Upper Trishuli-1
10238768
Design Advice on Fish Passages for the Upper Trisuli-1 Hydropower Project test

Client:
DOOSAN ENERBILITY Co., Ltd.

Design Advice on Fish passages for the

Upper Trisuli-1 Hydropower Project

PLAN P4–P4
ENTRANCE OF FISH LADDER DOWNSTREAM
Scale 1:100

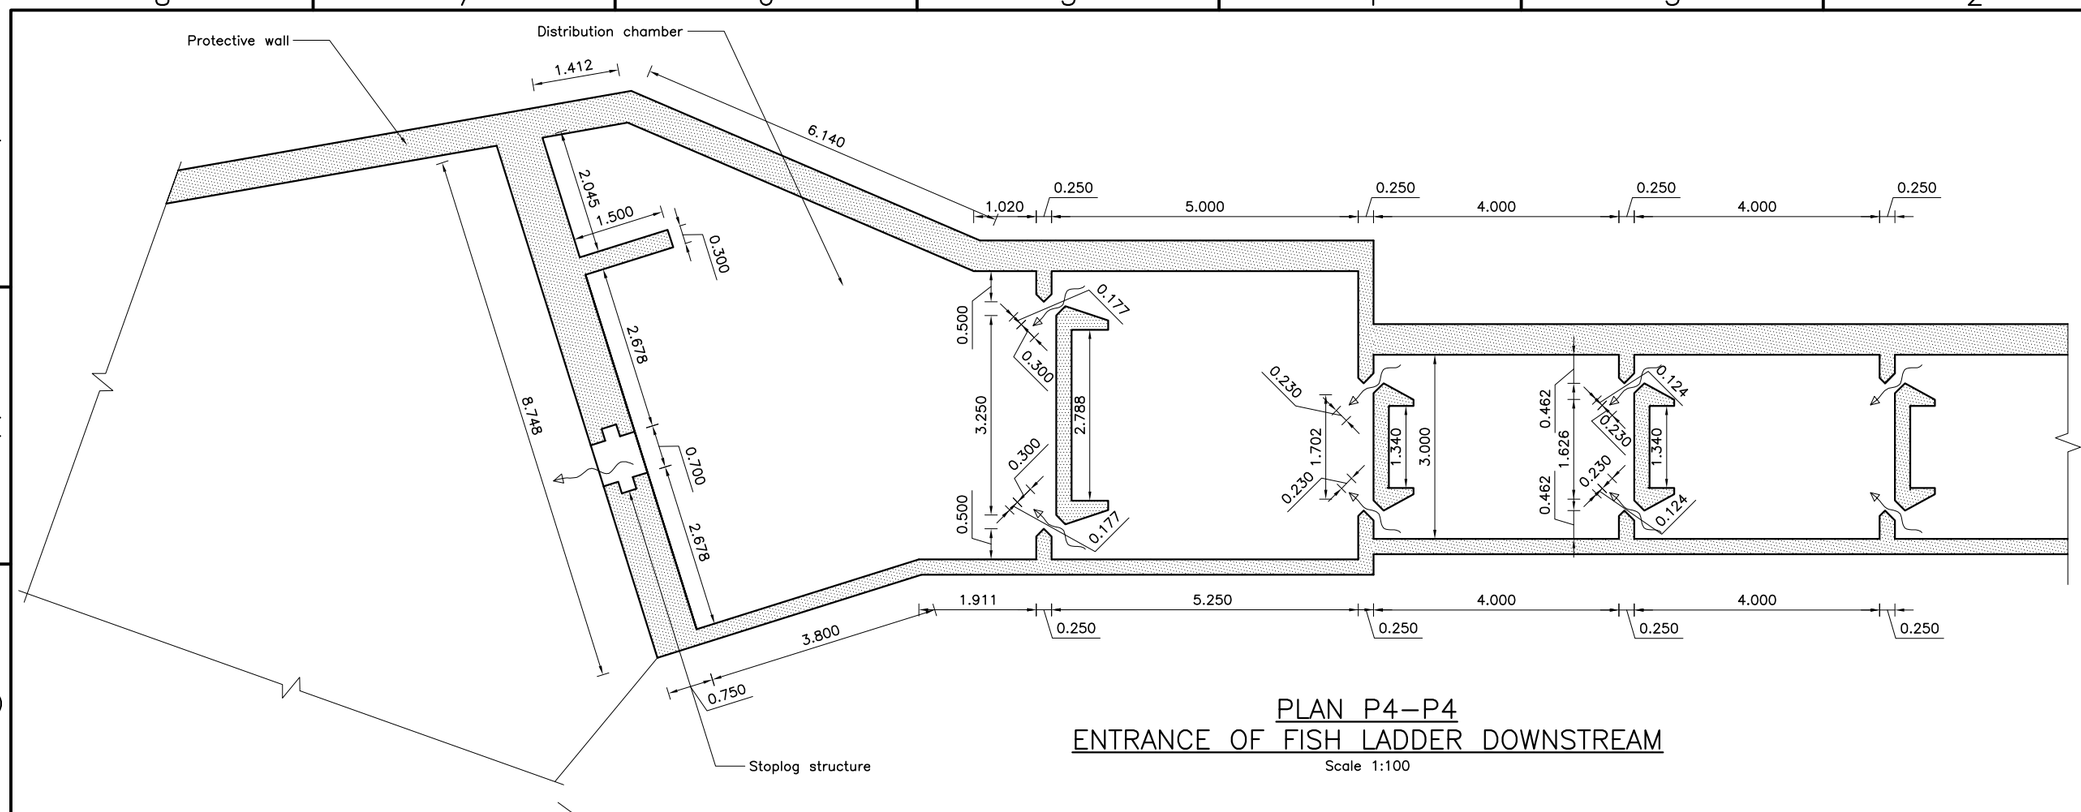
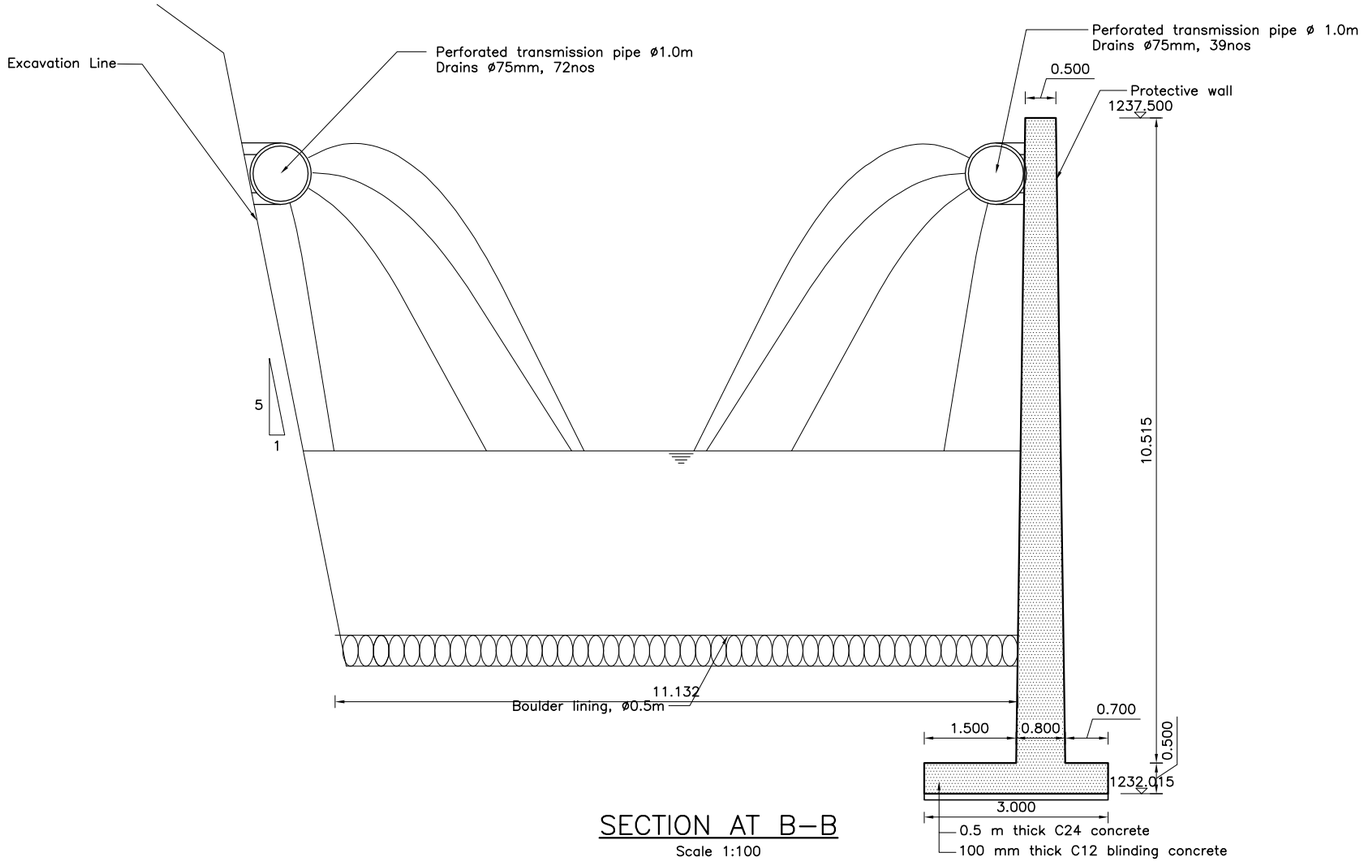
Ref. attached drawing -01, -03, -06, -07

The entrance pool is an excavated basin located adjacent the river course. It is approximately 24 m long measured along the centreline. Width varies between 9 m and 13 m. Floor is sloped and resulting max water depth is approximately 3.0 m. Some boulders are situated in deepest section of the chamber facilitating hiding spots for the migrating fish. The pool is framed by the excavated rock slope on one side and a protective wall on the river side. A boulder sill serve as the control unit.

The boulder sill in the outlet of the entrance pool (pool no 1) is approximately 10 m wide. It is assumed buried into the river ground and as a type where the gaps between the large boulders are closed. The boulders is assumed to consist of fieldstones. The sill is drowned by the river flow. Assuming Q = 4.0 m3/sec and ditto in the river, the sill is estimated to raise the water level by 0.075 m in the entrance pool.

If the entrance pool localisation as shall be decided by Doosan Enerbility is close to 1232 masl the protective wall must reach up to at least average monsoon flow level which might be close to 1235,5 masl. (HEC-Ras run with Q = 411.0 m3/sec)

Total water flow entering the entrance pool is planned as Q = 4.0 m3/sec of which Q = 1.5 m3/sec is fed from the upstream pool 2 via a stoplog-opening (Δh = 0.15 m), and Q = 0.3 m3/sec from pool 2 roof via an overflow weir. This flow is a free falling jet entering the water surface in front of the pool 2 stoplog-opening.

SECTION AT C–C

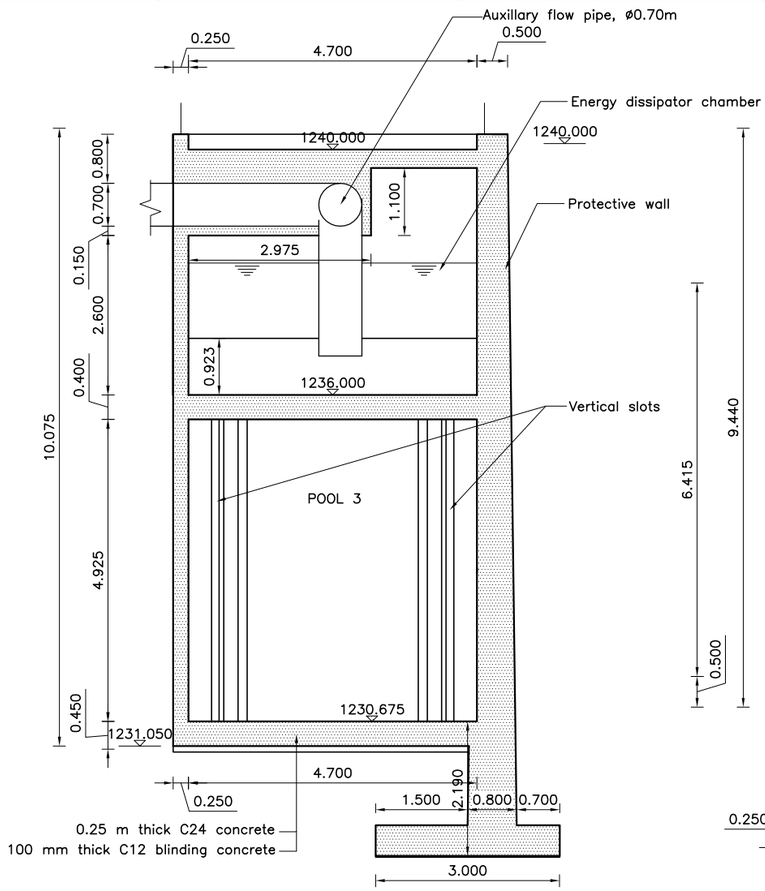
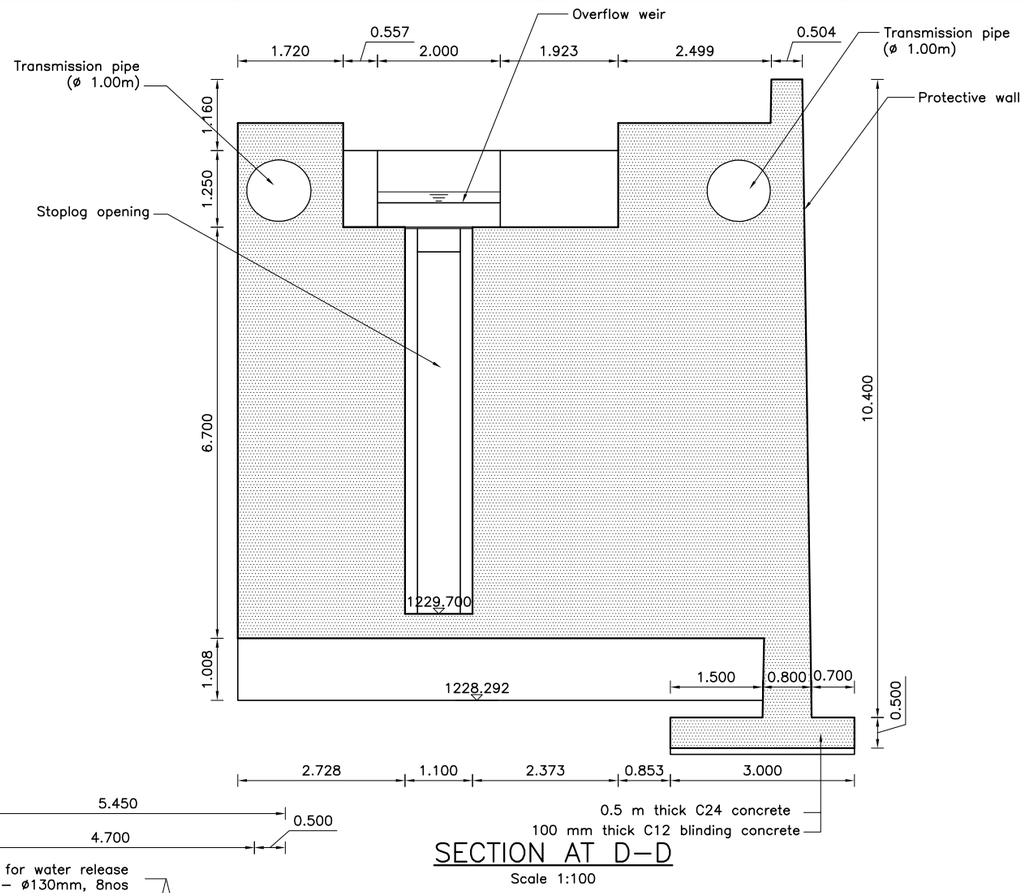
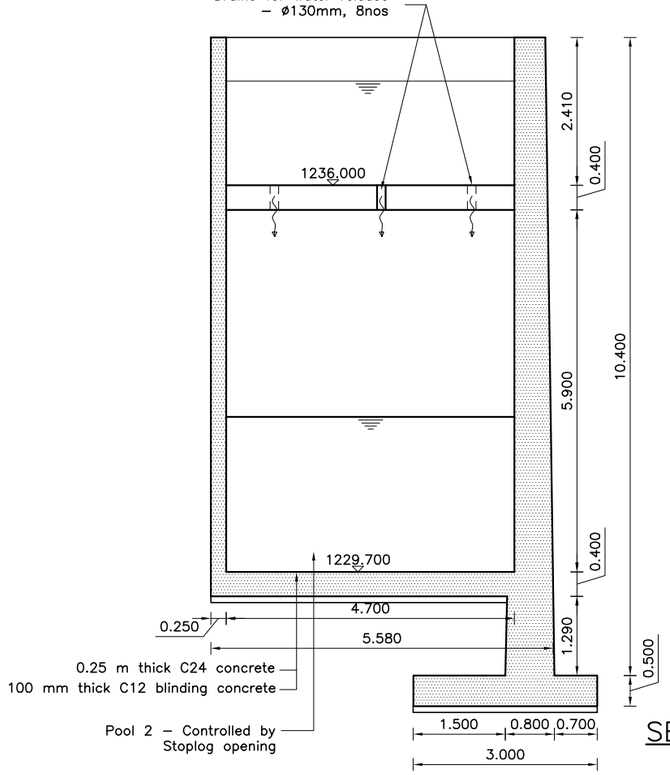
The drawings show height of each cross wall h = 2.5 m. These pools are all with no roof and facilitated for fish to enter both through the vertical slots and also by entering directly into the submerged pool areas during monsoon. During monsoon the entrance pool will be less effective than during the low flow period, but still working well.

Ref. attached drawing -03, -06, -07, -08

An assumed beneficial design worthwhile to consider in detail design will be to extend these cross walls to level the protective wall, thus providing support of this wall as well.

LONGITUDINAL PROFILE P–P OF D/S FISH LADDER

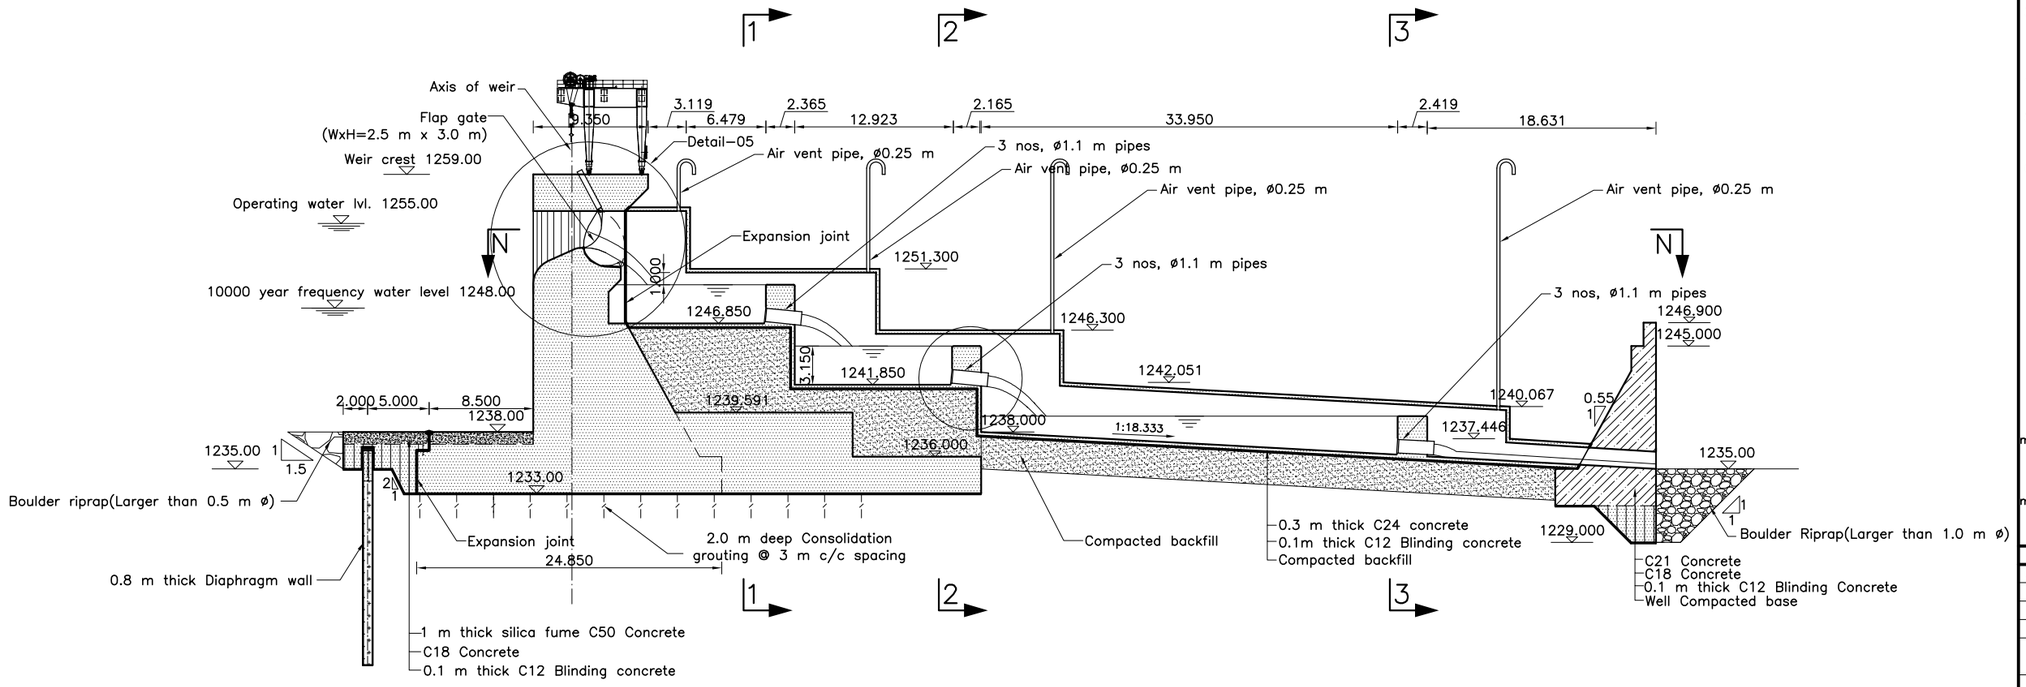
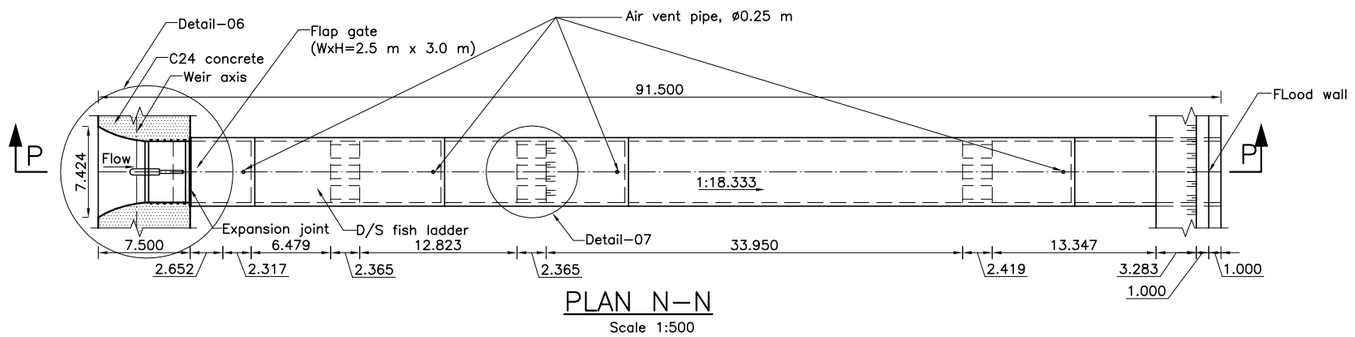
Ref. attached drawing -13, -14, -15, -16.

An important point is that fish migrating downstream across the weir should follow a fish friendly spillway and meet a soft landing in a downstream pool (see Sweco report of 15.08.2016, Fish Passage, evaluation of plans and recommendations, chapter 2.4).
When the flapped gates as designed at the top of the radial gates are used, they might serve as an opportunity for downstream migrating fish to pass over the weir. This will lead fish to fall 15 m and then hit the concrete basement. Heights above 5m will led to increased injurie and mortality. With a free fall of 15 m the fish will reach a velocity that even if hitting the water surface might cause high grade of injurie and mortality. To reduce the frequency of fish mortality due to passing through the flapped gates during monsoon, it is recommendable to use the flapped gates only short periods to empty for debris, and then to direct the excess water to a fish friendly spillway.
